# Addendum 04

**PROJECT:** Fort Loramie Local Schools Athletic Complex Building & Associated Improvements  
600 East Park Street  
Fort Loramie, Ohio 45845

**PROJECT #:** 25041.00

SHEET NUMBER: A1.1

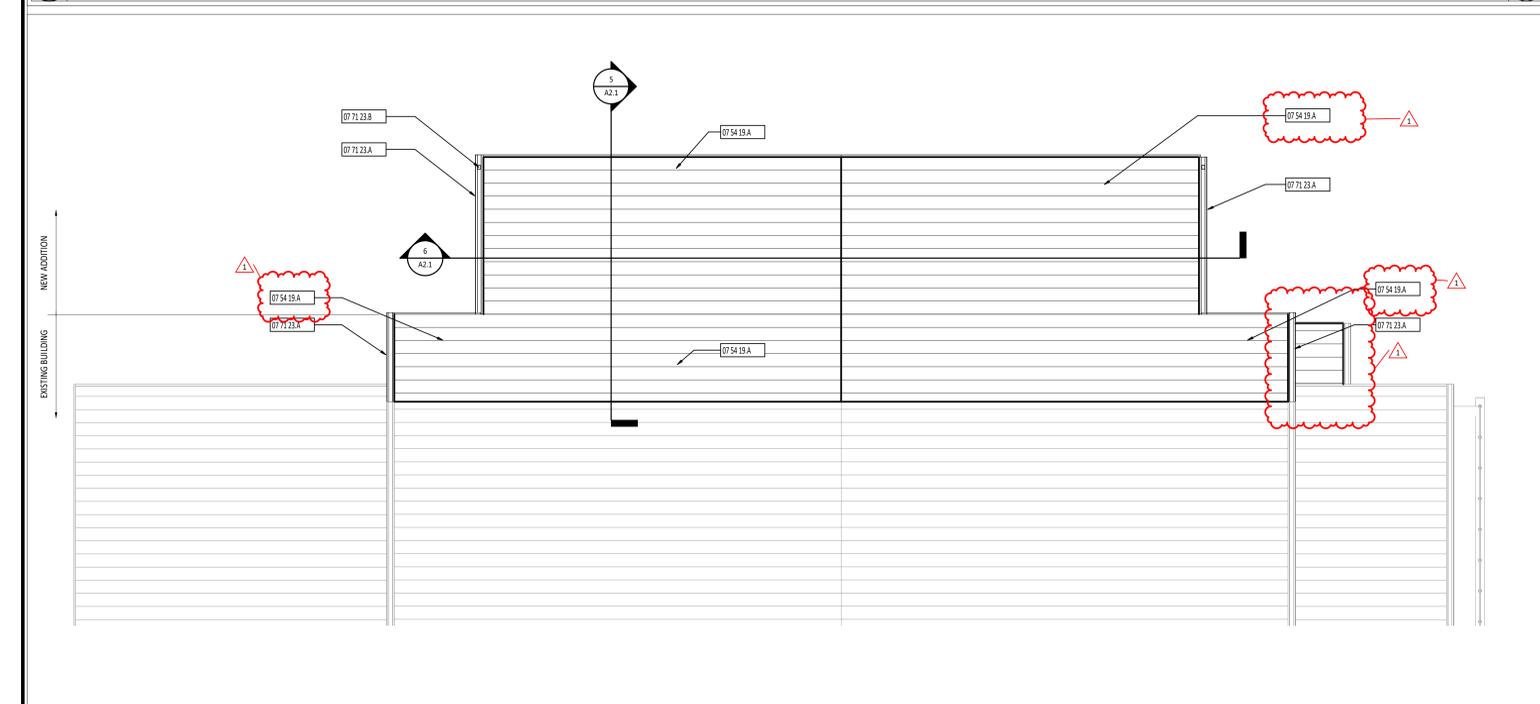
1. Sheet A1.1 – First Floor Plan
  - a. Add cementitious sound absorbing panel (Tectum) to roof deck and paint to match existing.
2. Sheet E1.2 - Electrical Details and Luminaire Schedule
  - a. Provided lighting equals.

SHEET NUMBER: A0.3

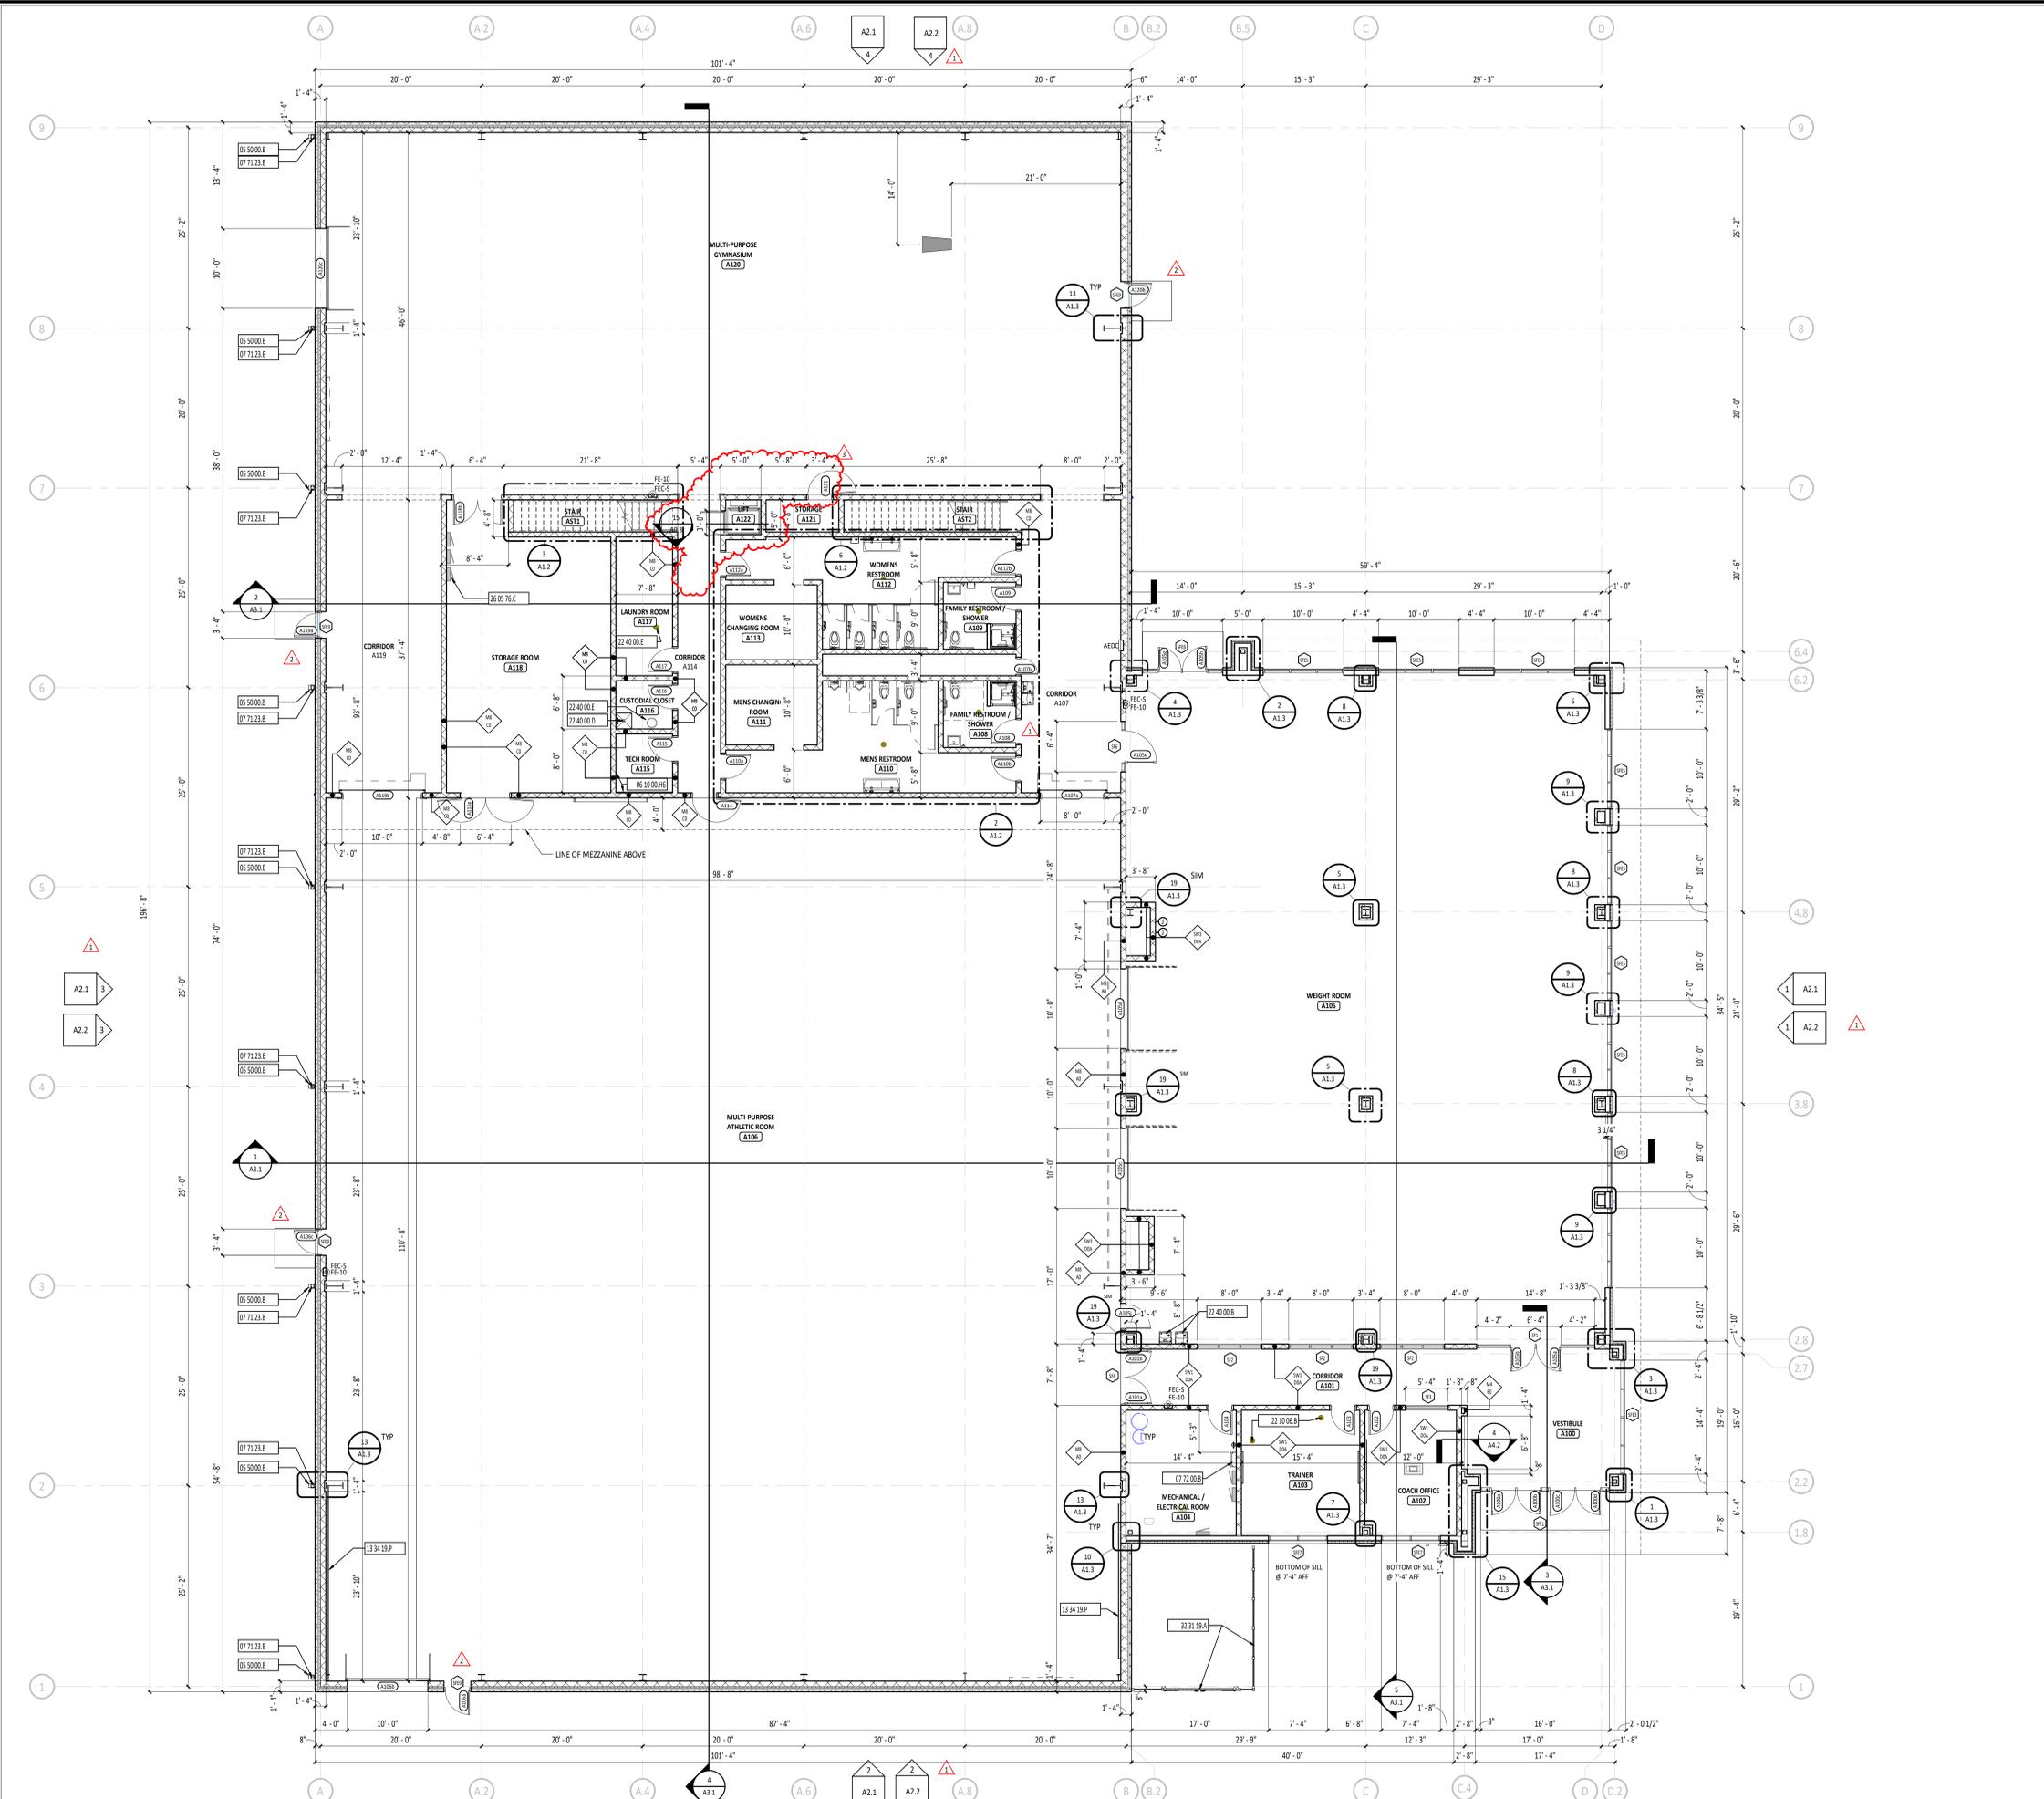
1. Sheet A0.3 – Typical Details
  - a. Add Section of wheelchair lift shaft and partial height wall.
2. Sheet A1.1 – First Floor Plan
  - a. Add Recessed Pit Wheelchair lift
  - b. Modify masonry wall and door A121 to accommodate shaft.

SHEET NUMBER:  
**A1.2**

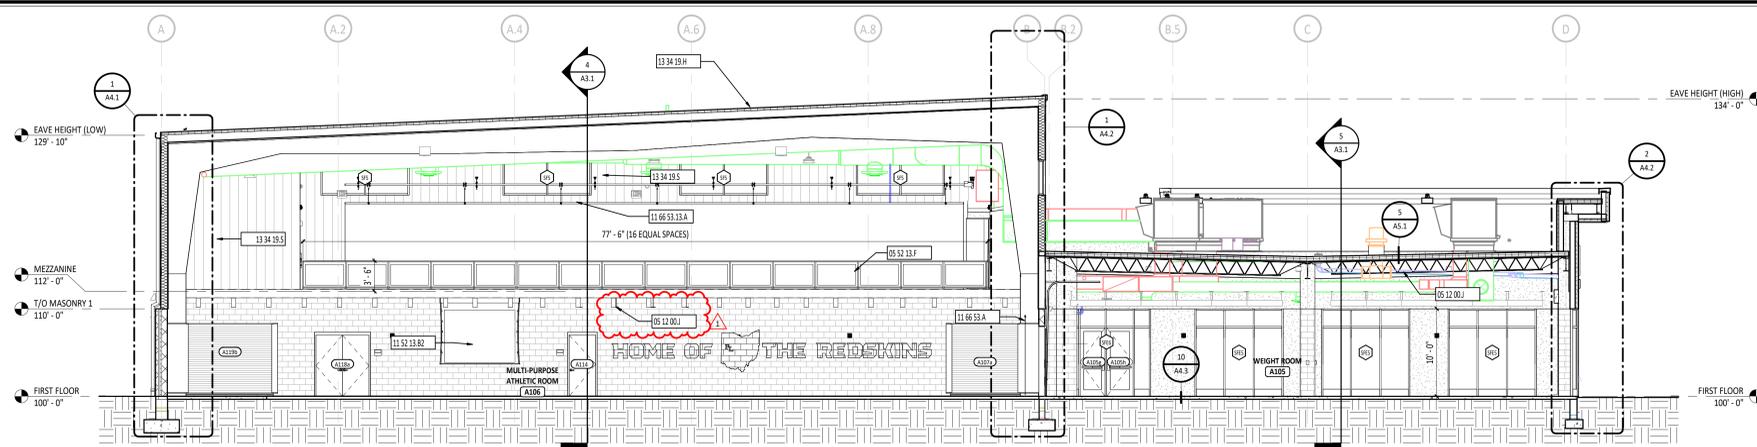
3. Sheet A1.2 – Mezzanine and Enlarged Floor Plan
  - a. Add Recessed Pit Wheelchair lift
  - b. Add Partial Height masonry wall with solid surface cap
4. Sheet A1.3 – Enlarged Column Plan and Stair Details

**SHEET NUMBER:**  
**A3.1**

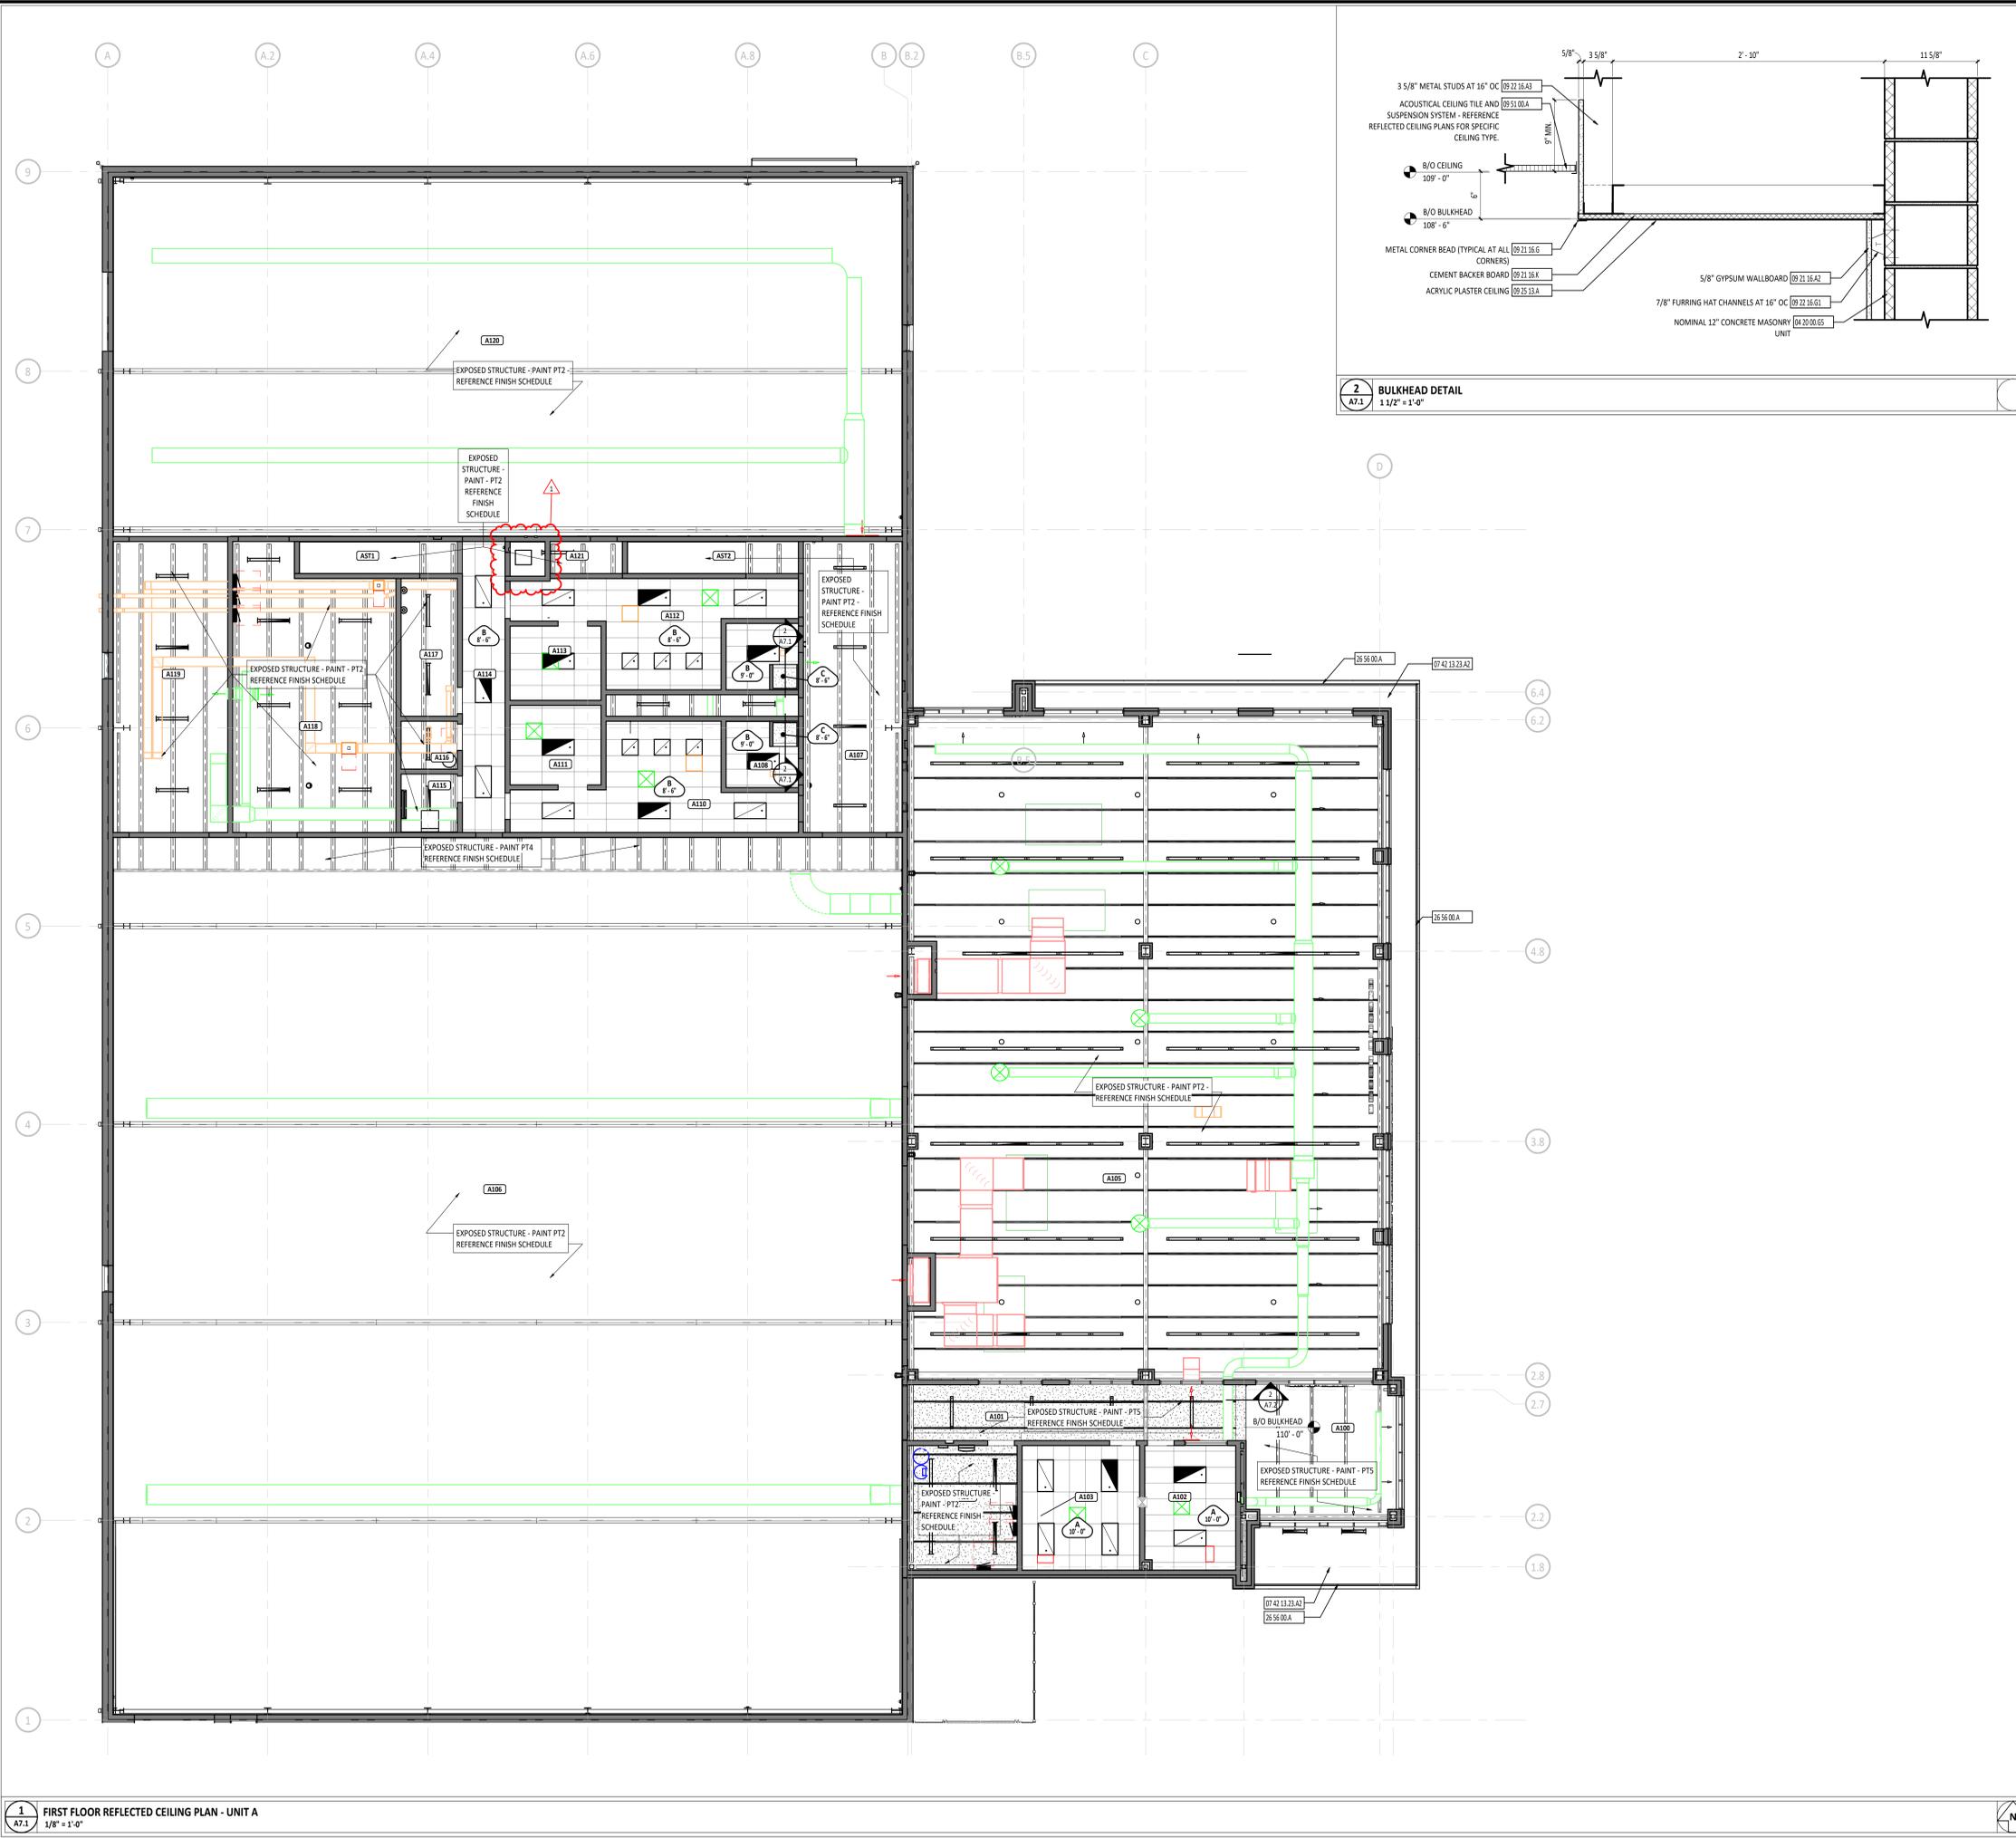
- a. Change keynote as indicated
  - b.
5. Sheet A3.1- Building Sections
  - a. Change keynote as indicated
6. Sheet A7.1 – First Floor Reflected Ceiling Plan
